# Access Compliance Report

## Public Rights-of-Way

Intersection ID: N/A	Main Street: CHARTER_OAK_LN	Cross Street: JOHNSTON_RD	Location: NE
ADA ID: 43AE8265B49C	Ramp Type: BlendTrans2	Initial Pass/Fail: Pass	Overall Compliance: No
Severity Score: 2.5			
Codes/Mitigation Info/Possible Solution		Field Measurements/Component Compliance

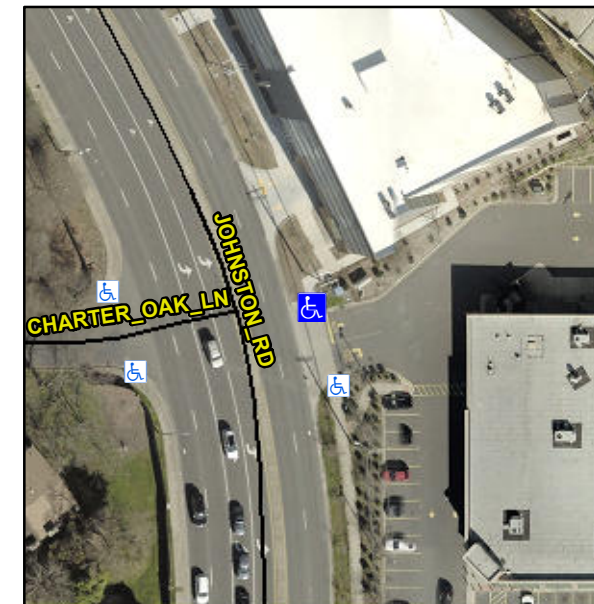
**Remove & Replace Curb Ramp With Two New Directional Ramps or Equivalent.**

**R304.2.3, R305.1.4**
